ADDENDUM NO. 3

CAESARS LANE
WASTEWATER TREATMENT PLANT EXPANSION
PHASE 2 PROJECT

TOWN OF NEW WINDSOR
ORANGE COUNTY, NEW YORK

DATE: June 27, 2025
JOB #: 18-732

SHEET NO.
C-410

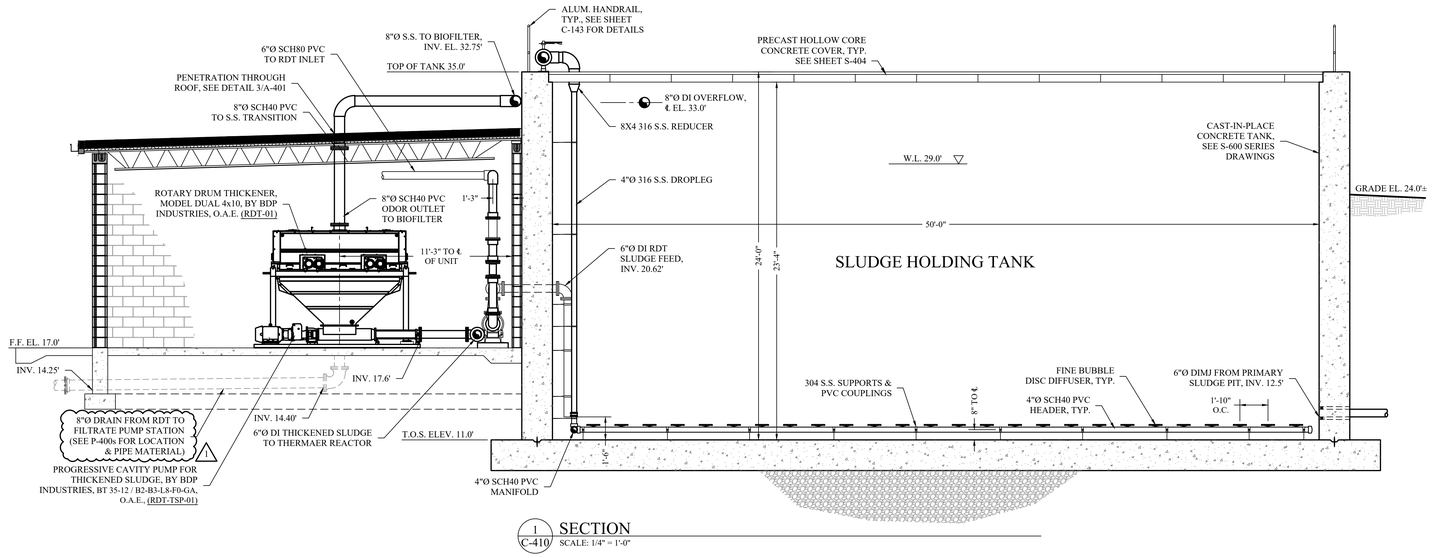
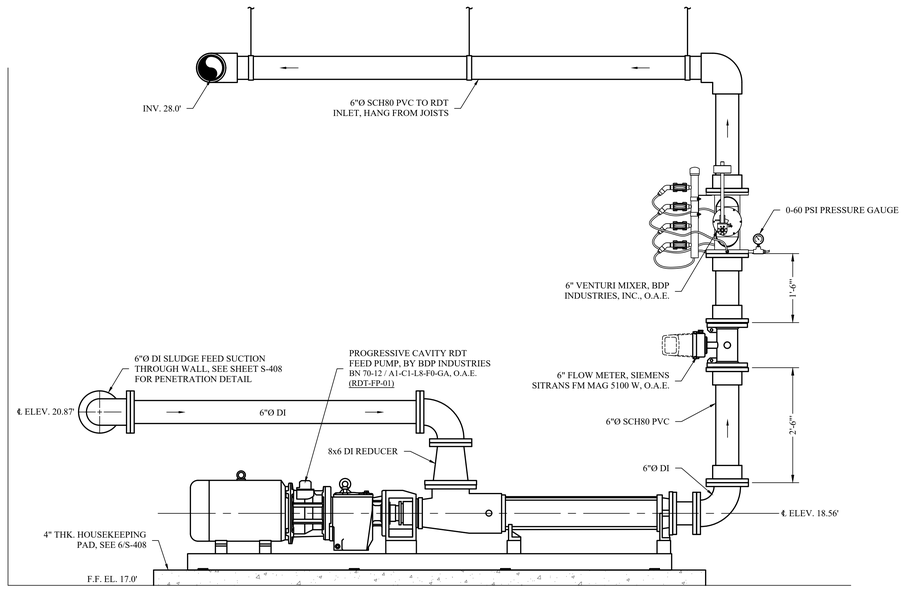
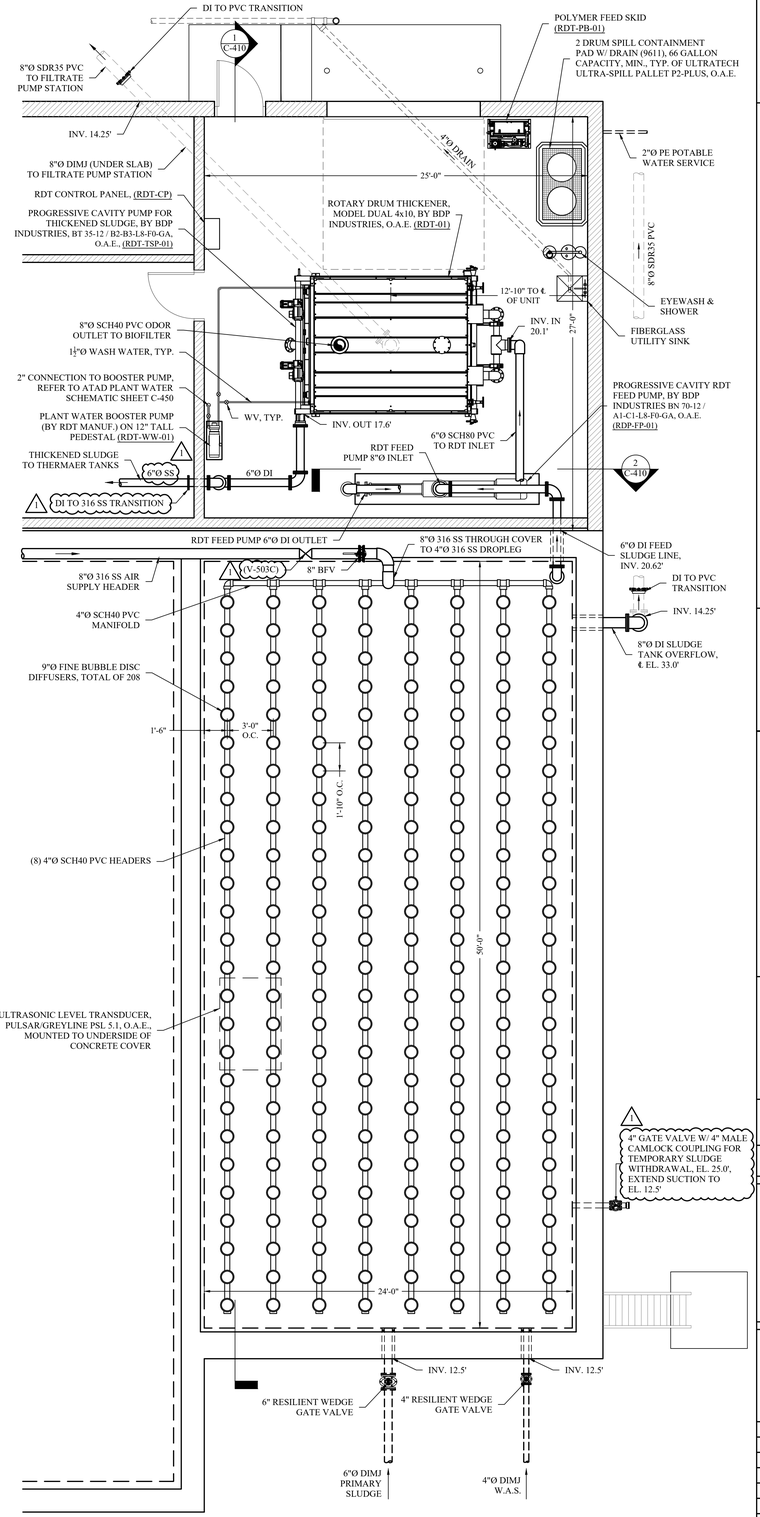
3. **Question:** Plan sheet C-410 and C-421, can the Owner/Engineer specify where the transition on the Thickened Sludge to Thermaer Tanks is to be located from DI to SS.
   Response: Piping within the ATAD room to be SS and piping within Rotary Drum thickener to be DI. Transition from DI to SS has been located on C-410 and C-421.

A / C-421 A.T.A.D. FOAM CONTROL SYSTEM IN-BASIN PLAN

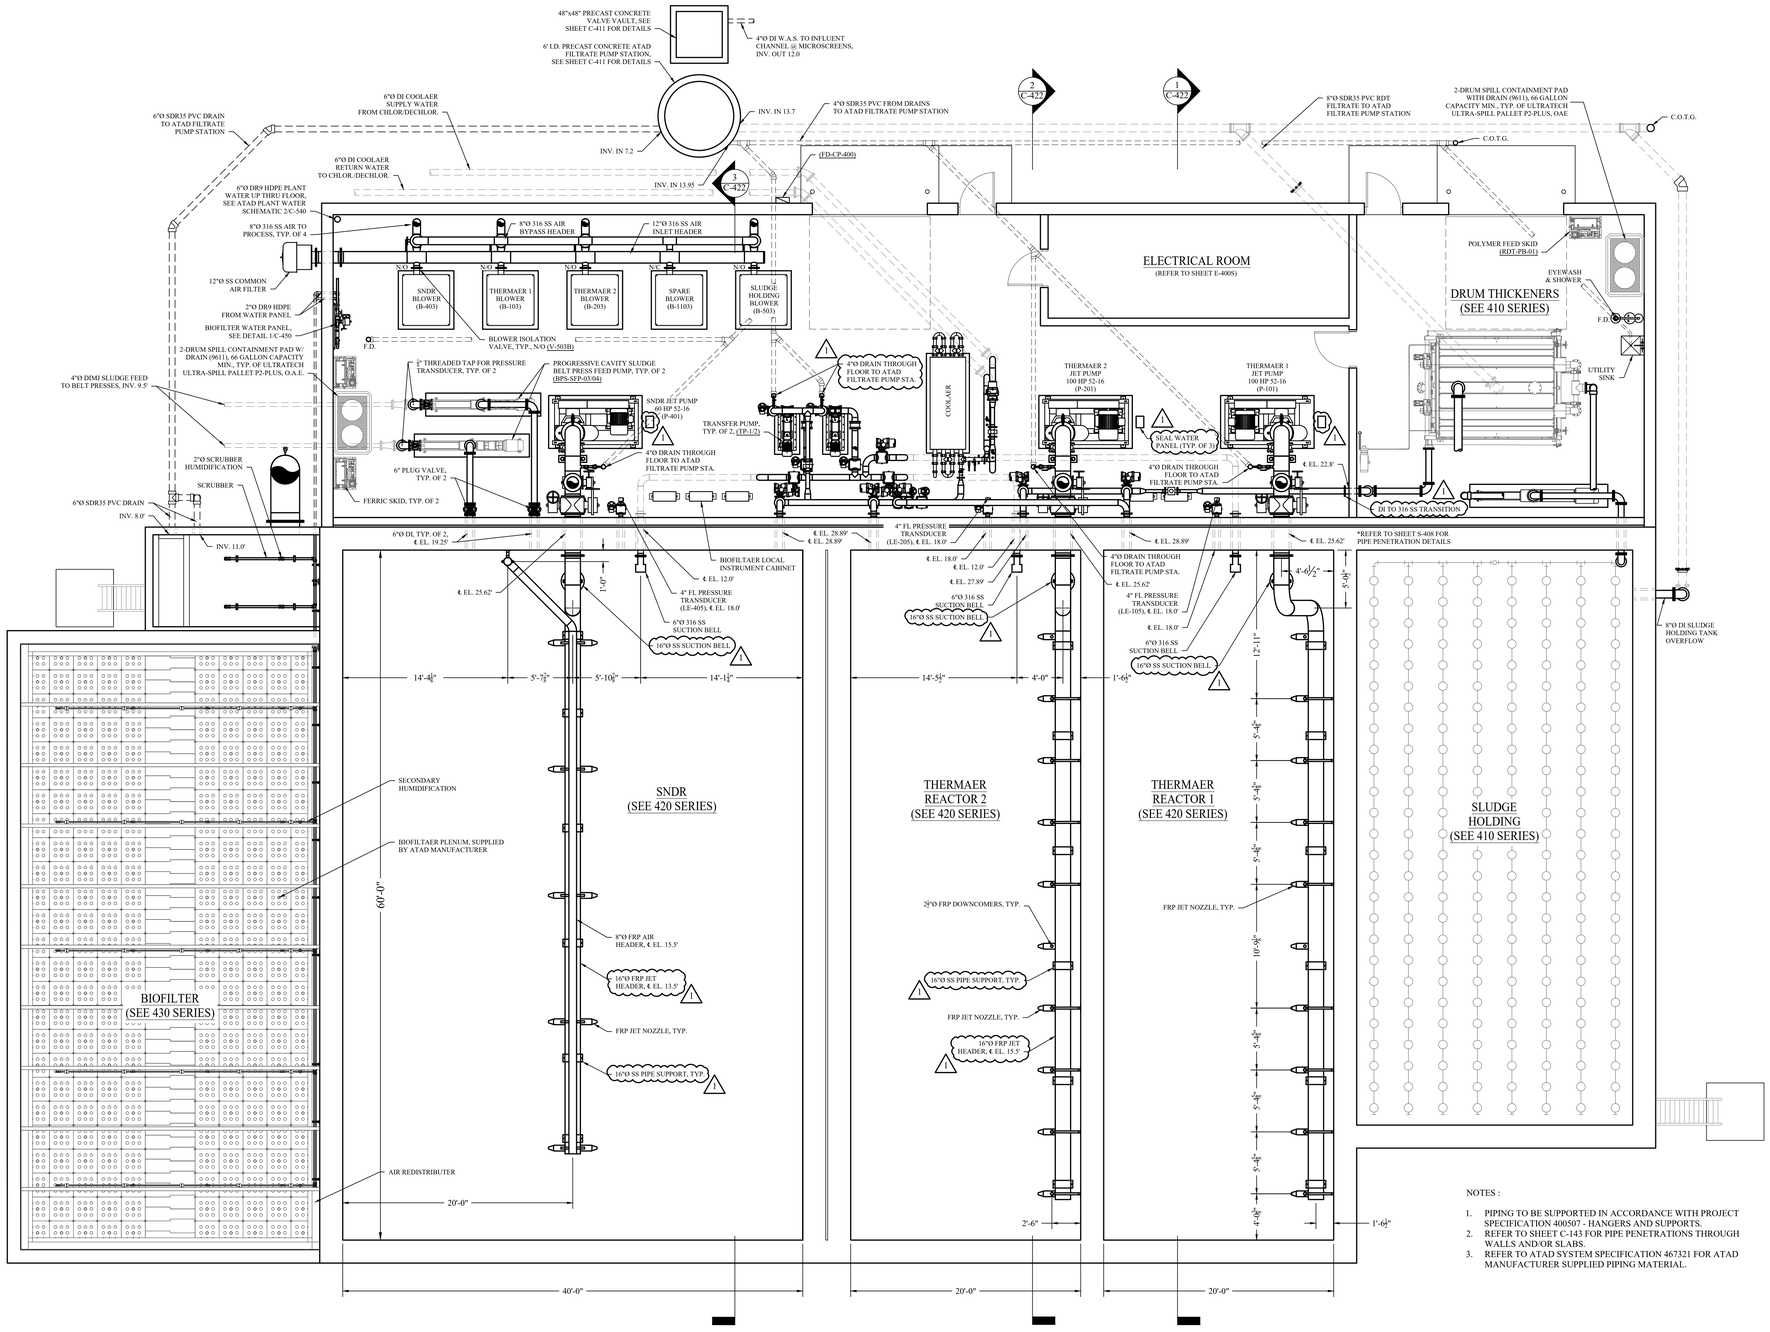
16. **Question:** Can the Owner/Engineer clarify if the 6" transfer line in the A.T.A.D is to be SS or DI. Transfer line callouts seem to be conflicting from C-421 and C-422.
    Response: The transfer line shall be 316 SS. Sheet C-422 has been revised accordingly.

SHEET NO.
C-422

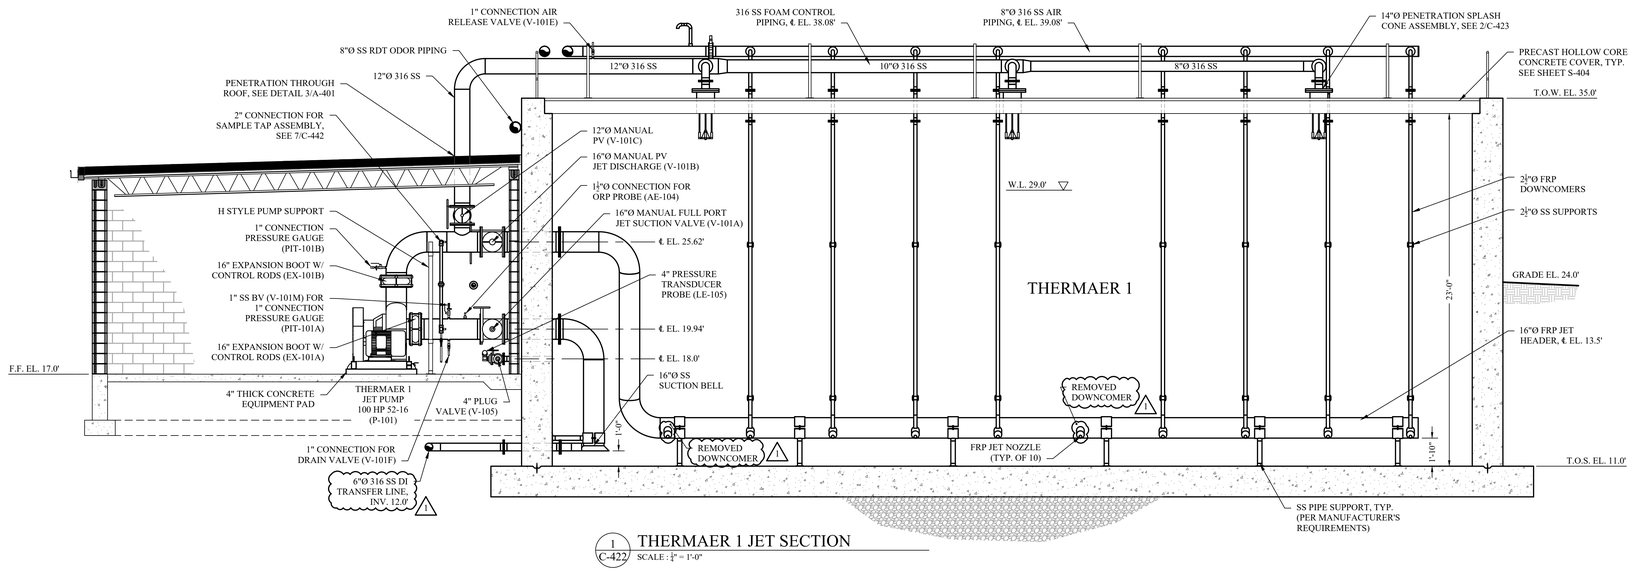
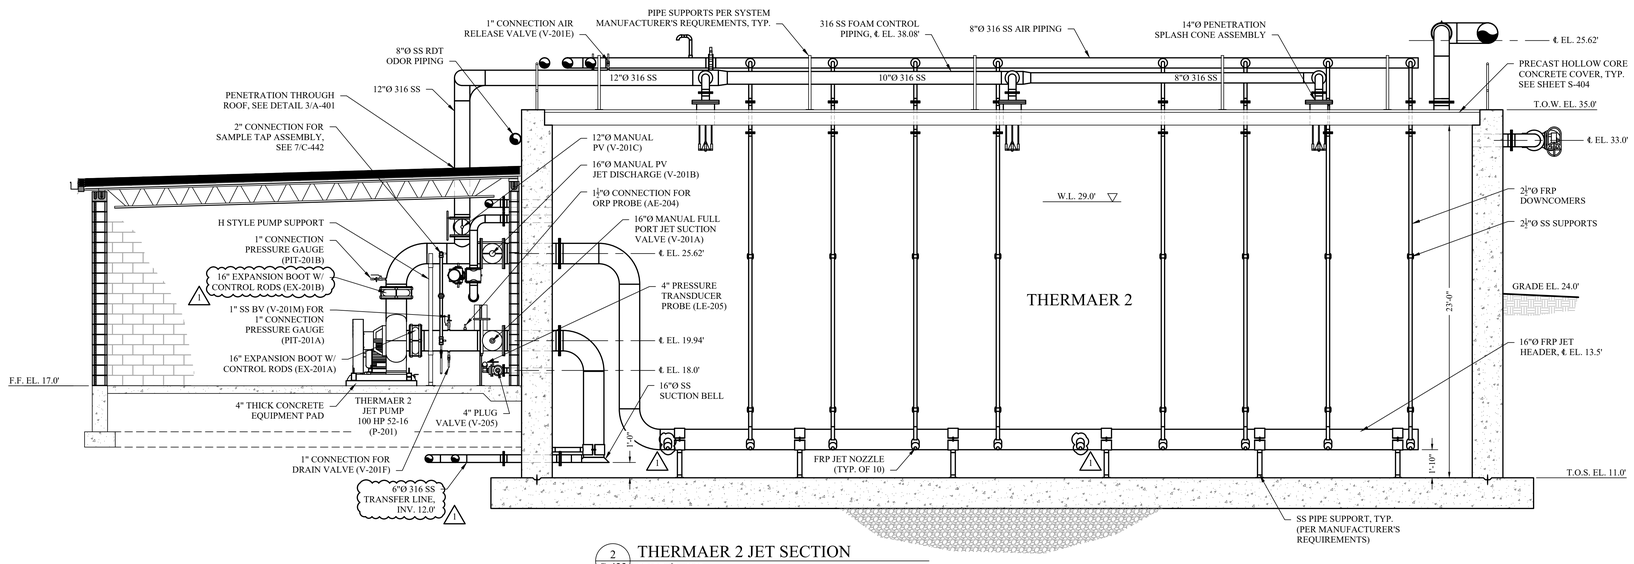
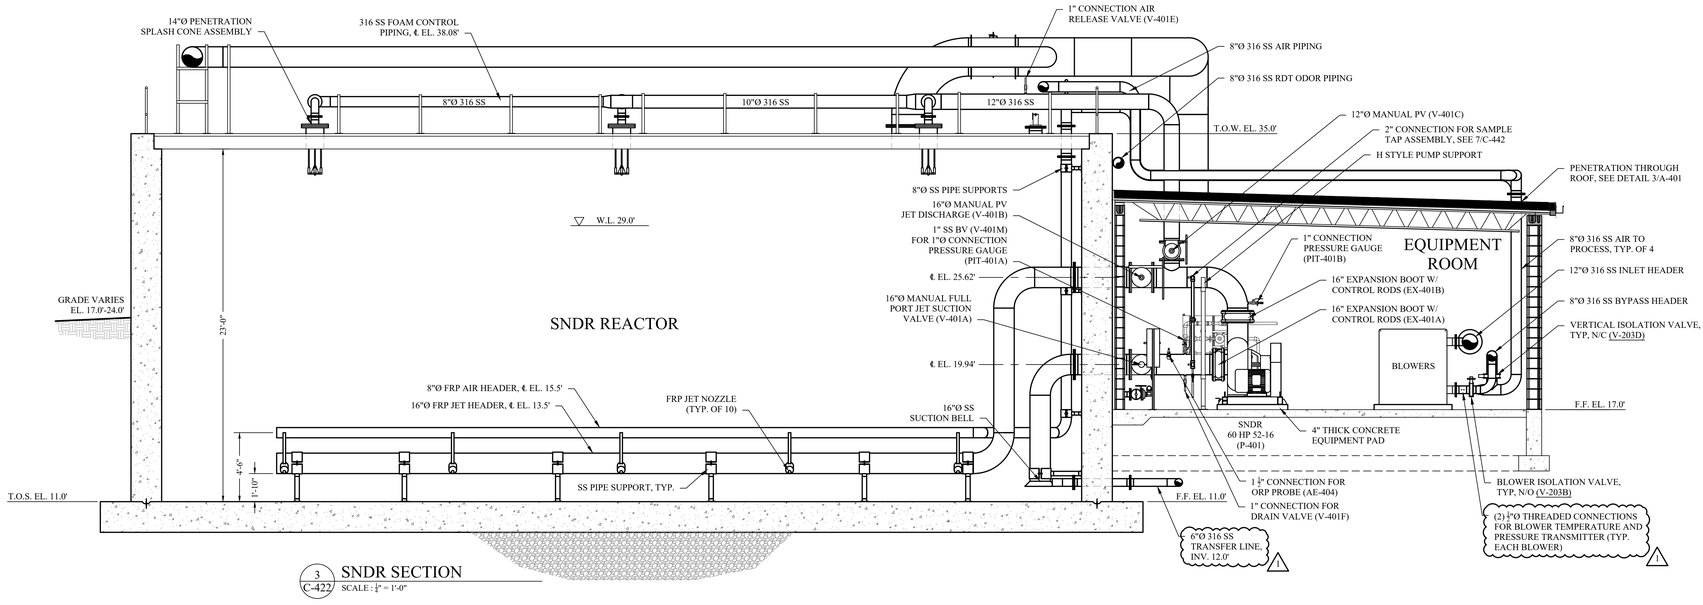
19. **Question**: Can the Owner/Engineer verify the suction bells sizing for the Jet pumps, they differ on plan sheets C-421 and C-422.
    Response: Jet pump suction bell shall be 16" as shown on Sheet C-422**.**

2 C-450 ATAD PLANT WATER PROCESS SCHEMATIC
SCALE: NONE

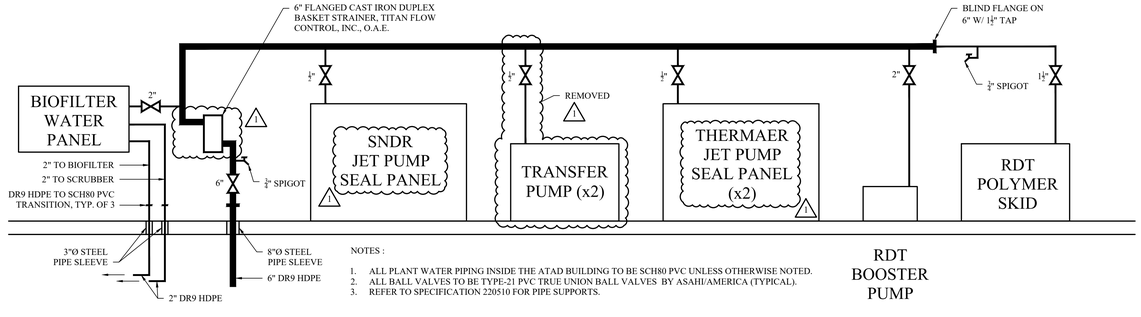
5. **Question:** Plan sheet C-450 detail 2 shows multiple valves of various sizes, can the Owner/Engineer specify the type and style for each valve or is it assumed all valves are ball type?
   Response: The valves shown in detail 2 on Sheet C-450 are ball valves.

6. **Question:** Plan sheet C-450 detail 2 note 1 states: all plant water piping inside the ATAD is to be Sch 80 unless otherwise noted. Specifications – PVC Process Piping 402323-4.C. Solvent weld joints may be utilized on piping less than 3" in diameter provided pressure ratings are met. Plant water piping is identified as 6", please identify the pipe material.
   Response: Solvent welded joints may be used on the 6" SCH80 PVC plant water lines.

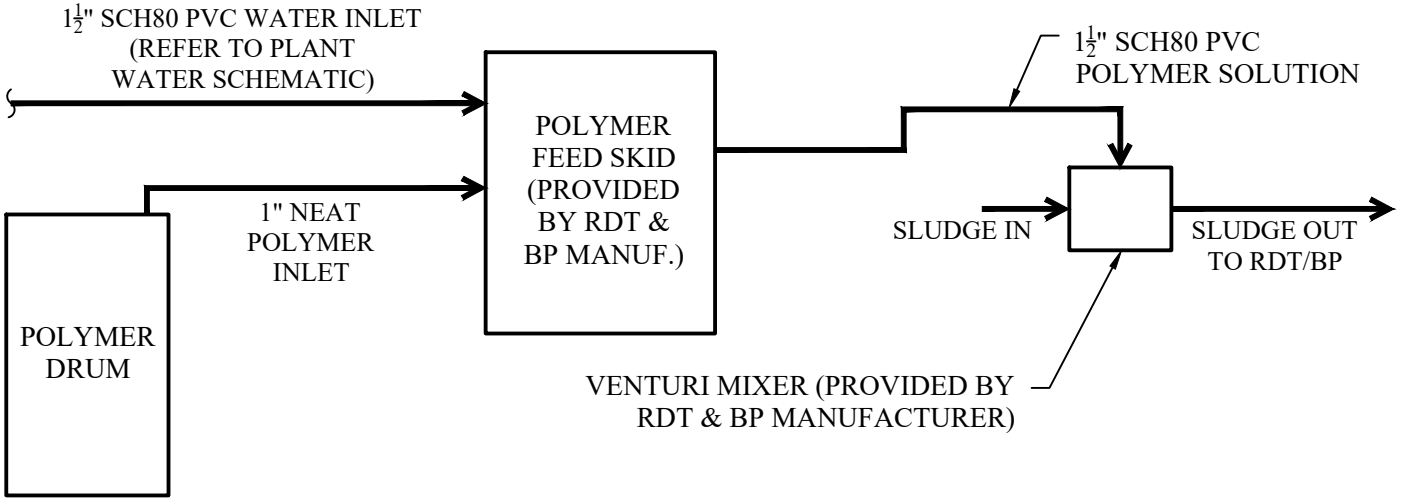
3. SK-1 Polymer Feed Schematic is provided in this addendum for clarification. This schematic applies to piping for polymer feed skids in the Drum Thickener Room (Sheet C-410) and in the Dewatering Building (Sheet C-702).

17. **Question**: On plan sheet C-542 in the Drum Thickener room there is a Polymer feed skid. Can the Owner/Engineer indicate the location/schematic of this piping?
    Response: Assuming this question references the Drum Thickener room shown on Sheet C-410, SK-1 Polymer Feed Schematic is provided in this addendum for clarification.

18. **Question**: On plan sheet C-702 in the Dewatering Building there are two Polymer feed skids. Can the Owner/Engineer indicate the location/schematic of this piping?
    Response: SK-1 Polymer Feed Schematic is provided in this addendum for clarification.
